RE: Spark - Manassas Battlefield, VA
Hilton Project #24-03203CV / Facility ID 62566
Interior Documentation

24-03203CV_HDR_SPARK MANASSAS EXTERIOR RENDERING 07112025.pdf Markup Summary

EXTERIOR CONVERSION
6950 NOVA WY, MANASSAS, VA 20109

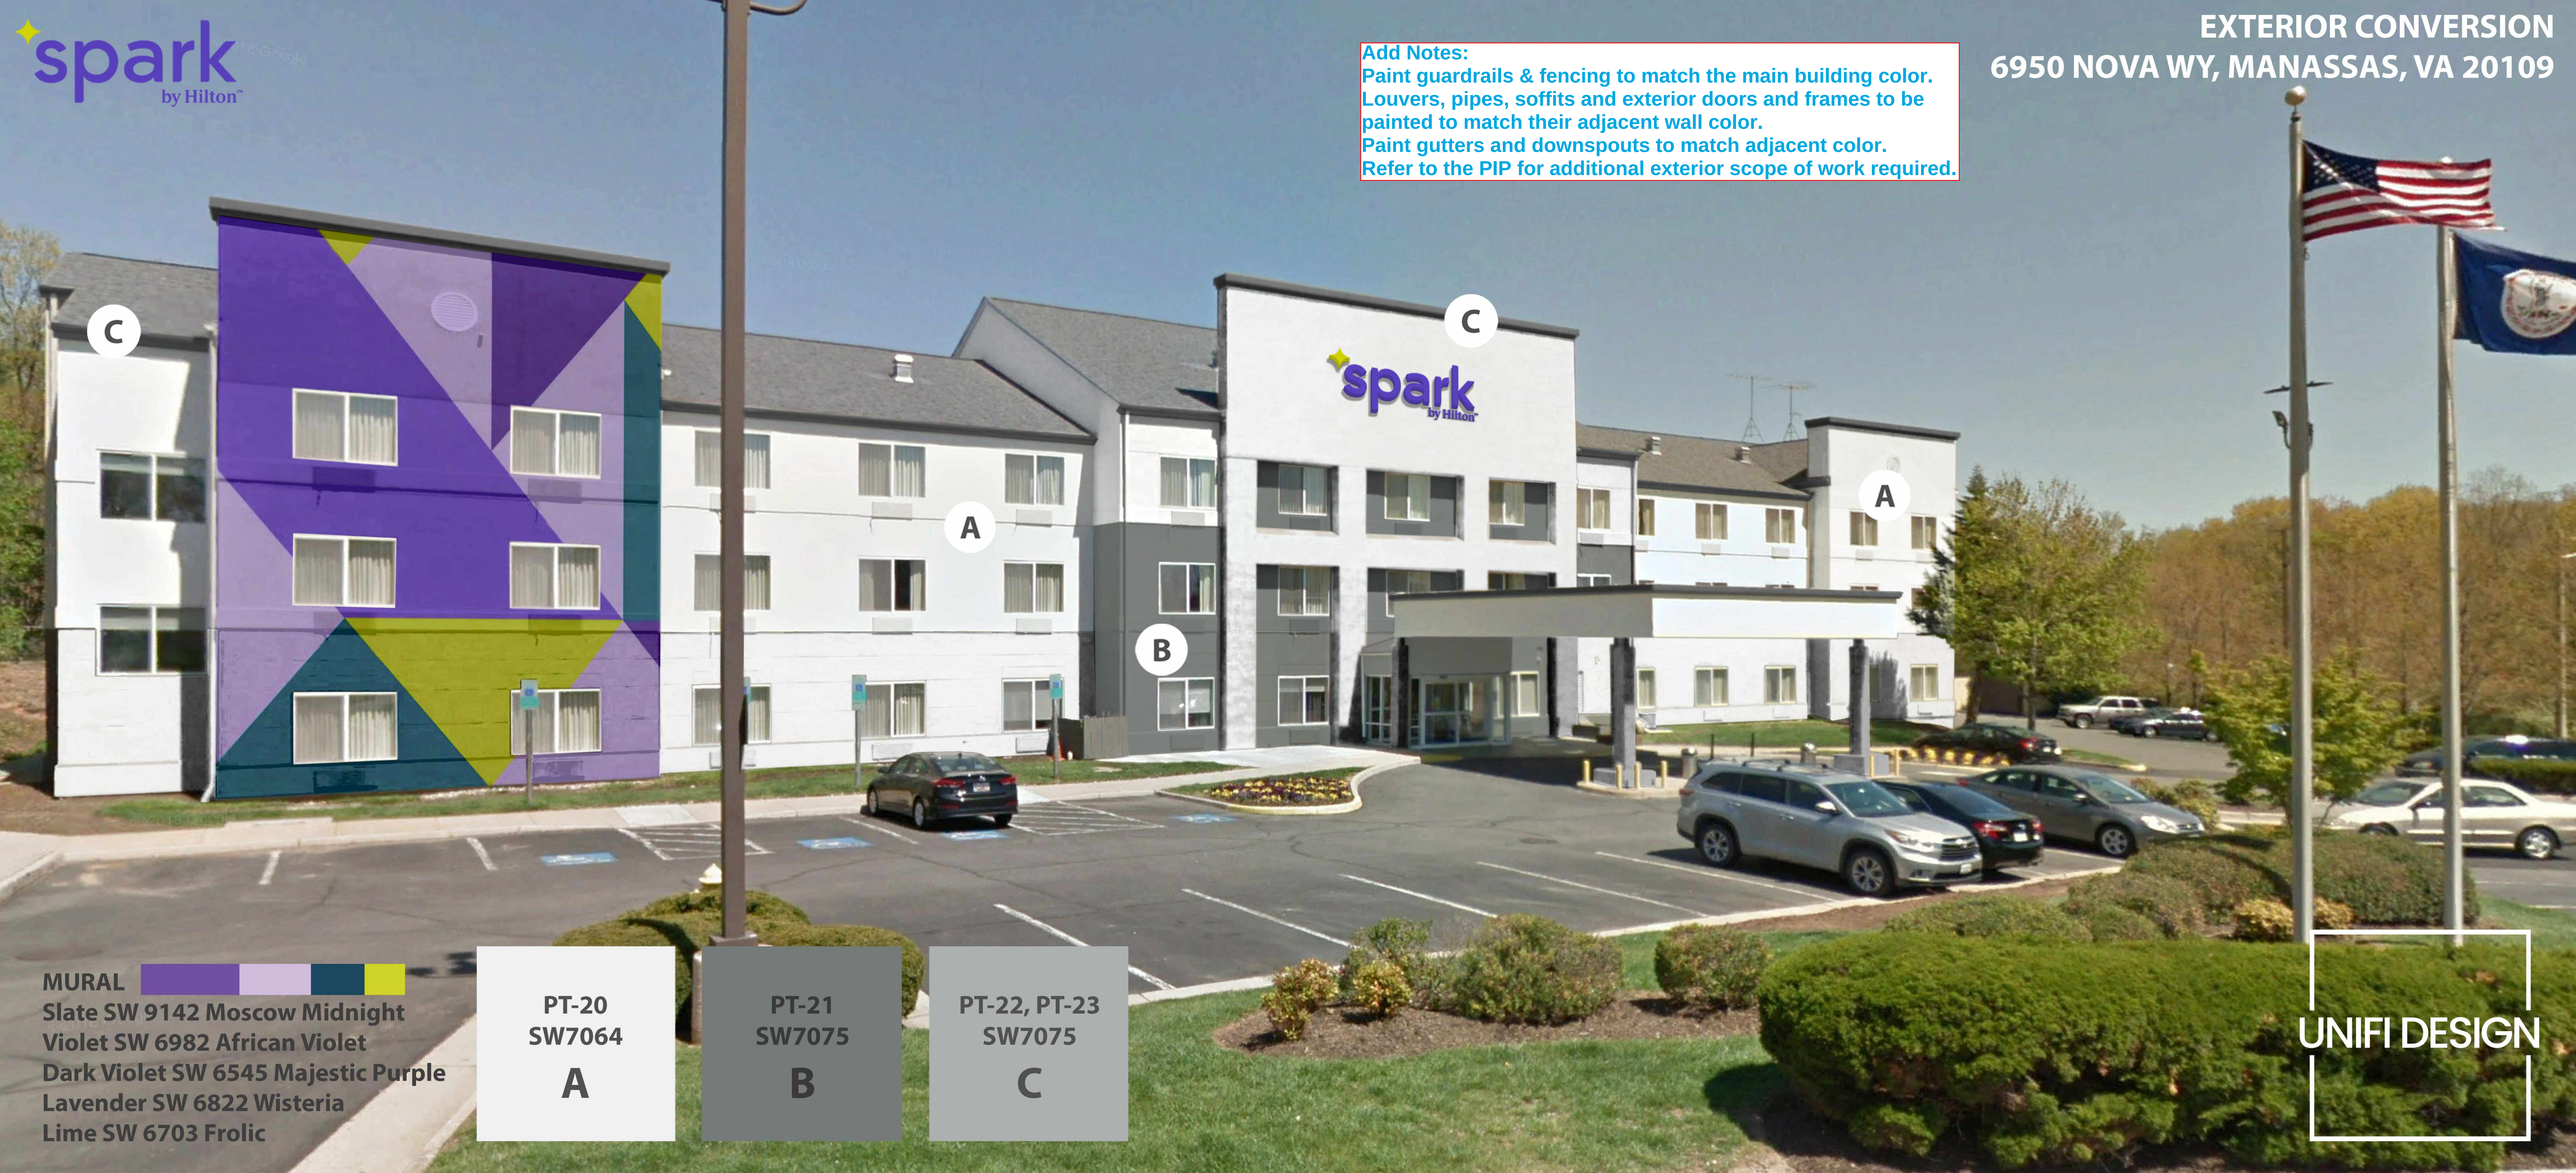
Add Notes:
Paint guardrails & fencing to match the main building color.
Louvers, pipes, soffits and exterior doors and frames to be painted to match their adjacent wall color.
Paint gutters and downspouts to match adjacent color.
Refer to the PIP for additional exterior scope of work required.

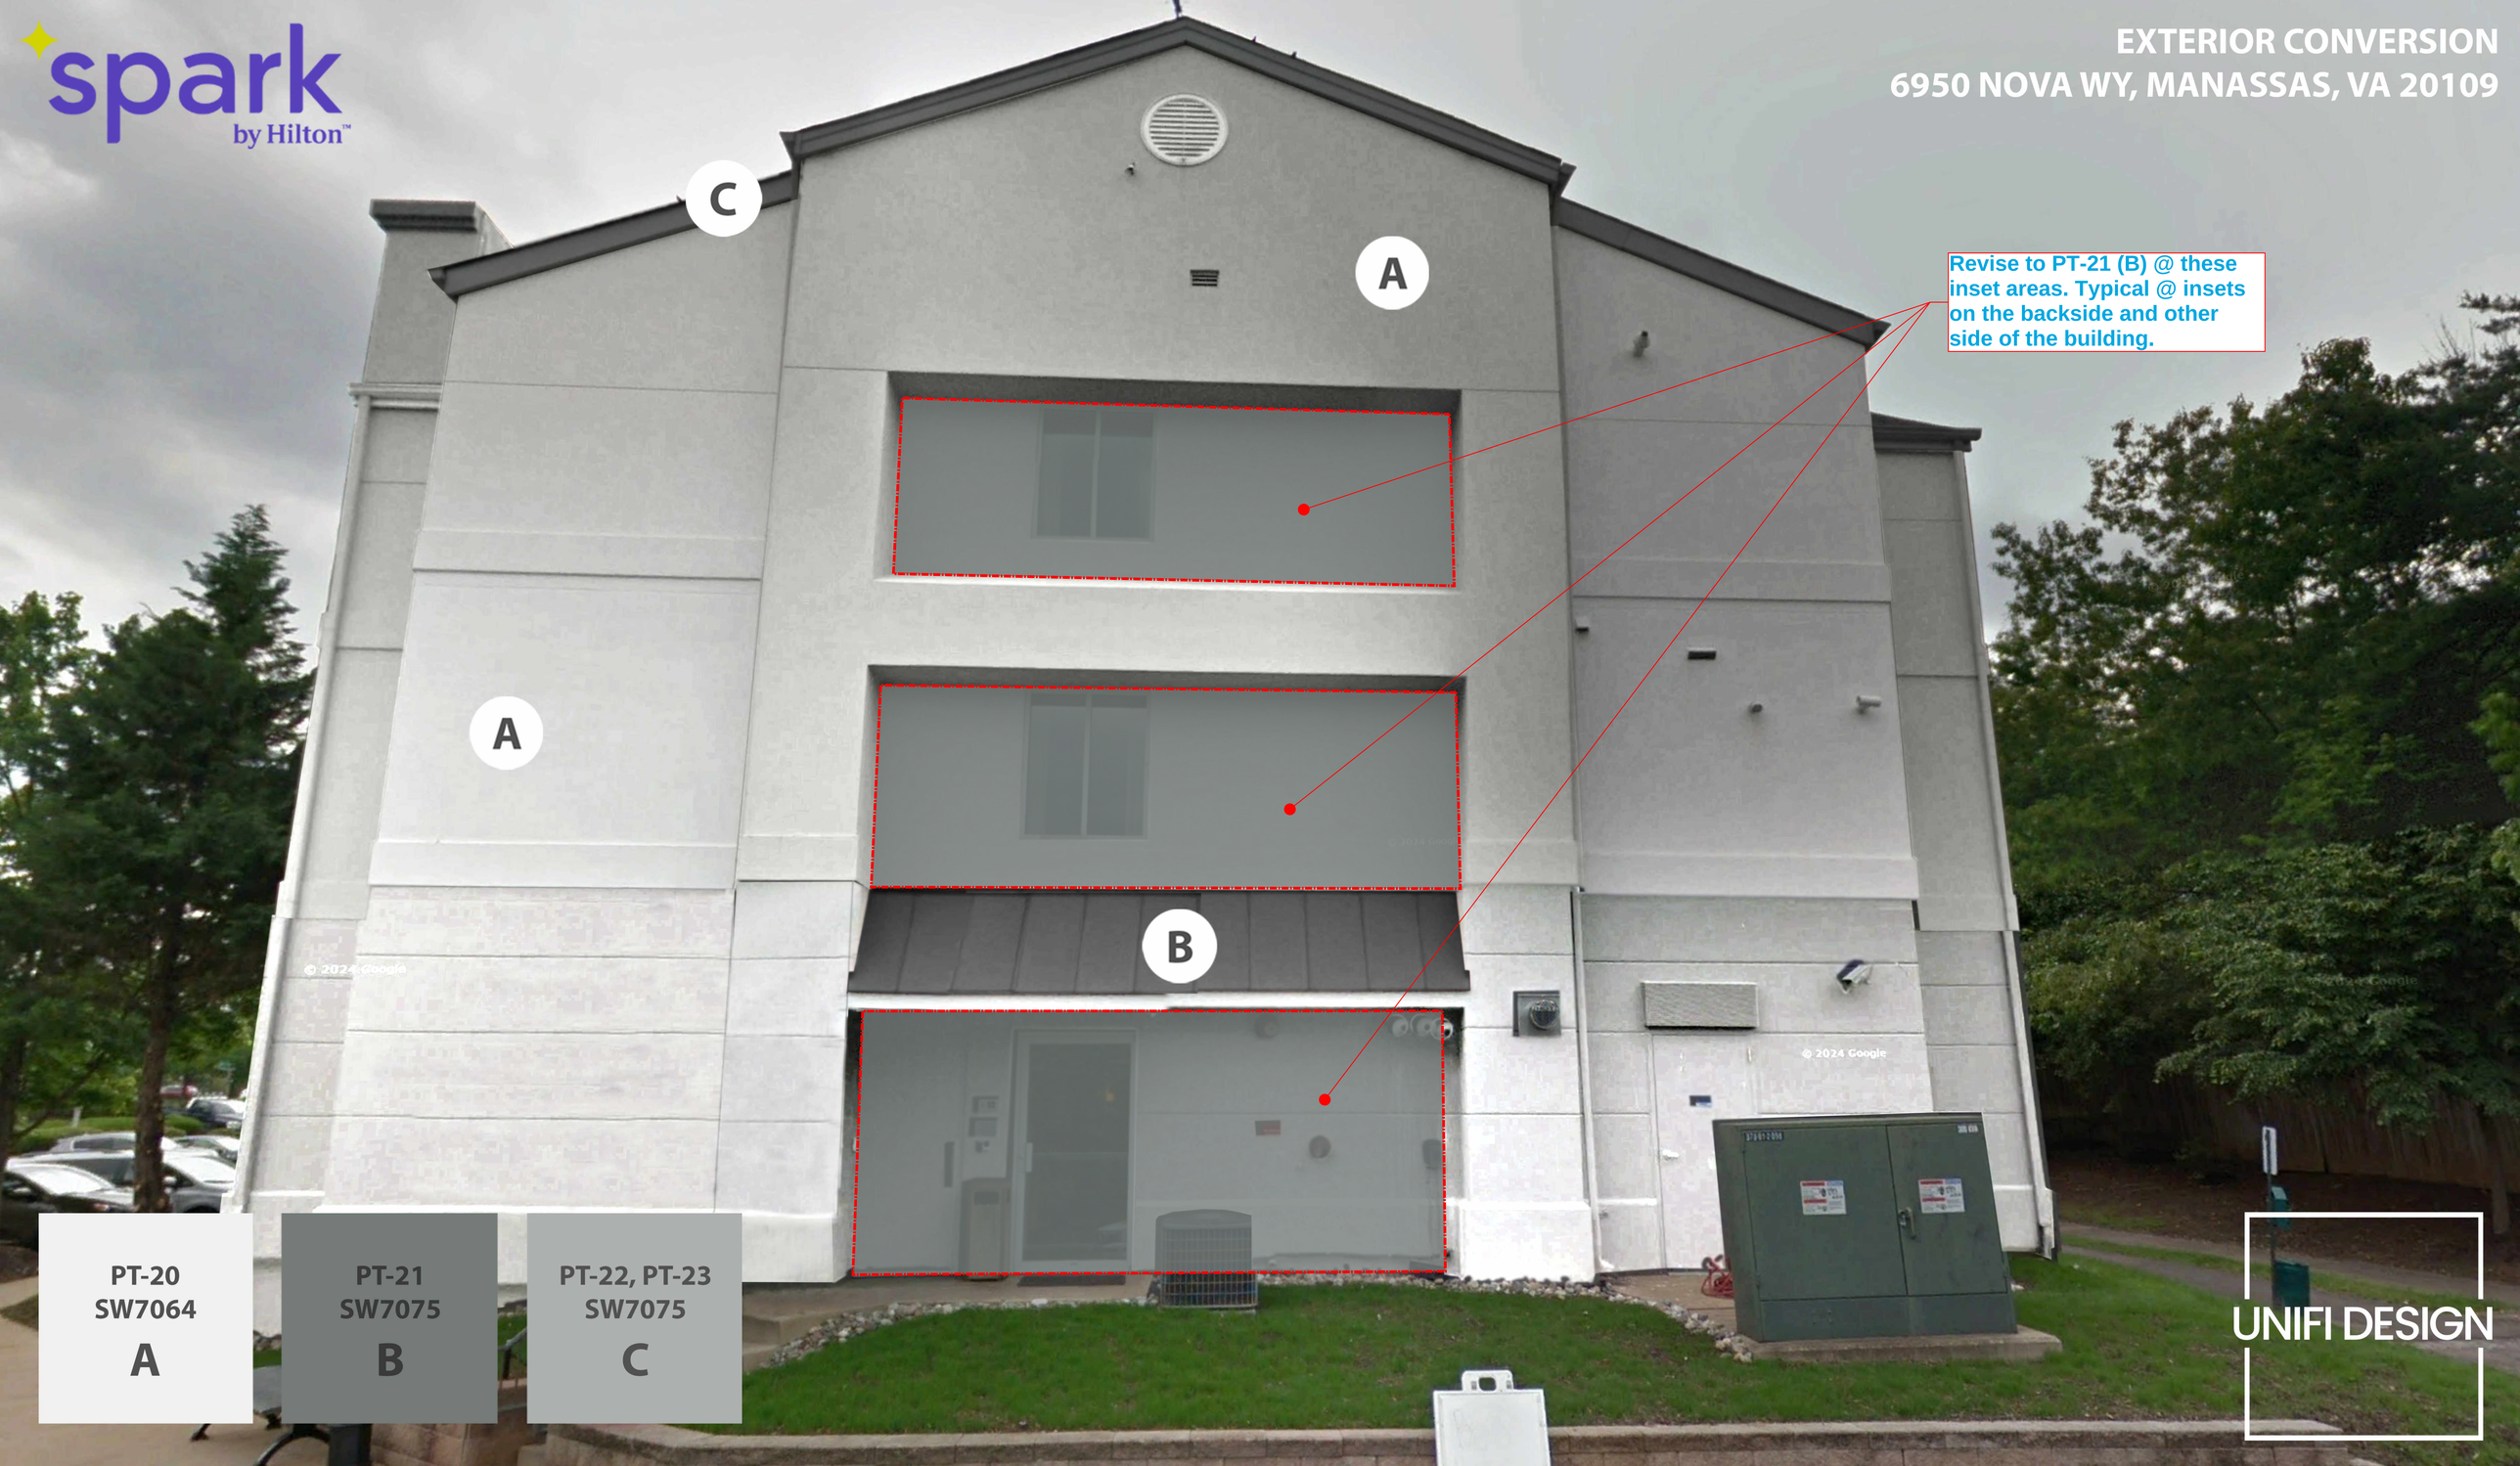
Revise to PT-21 (B) @ these inset areas. Typical @ insets on the backside and other side of the building.

2 CARPORT MURAL PLAN

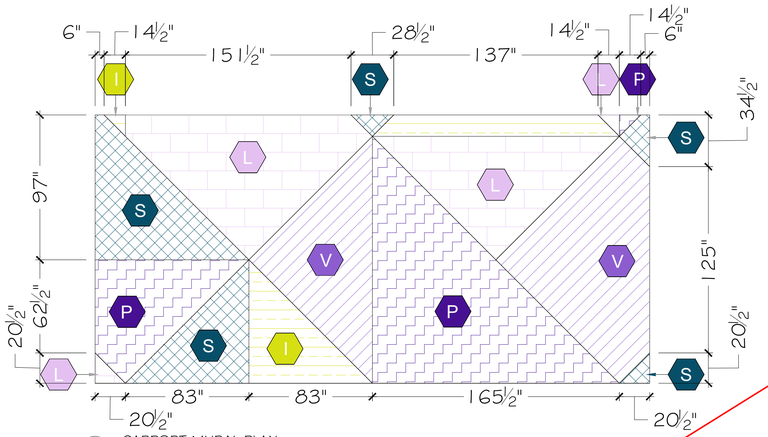
Show mural to wrap sides:
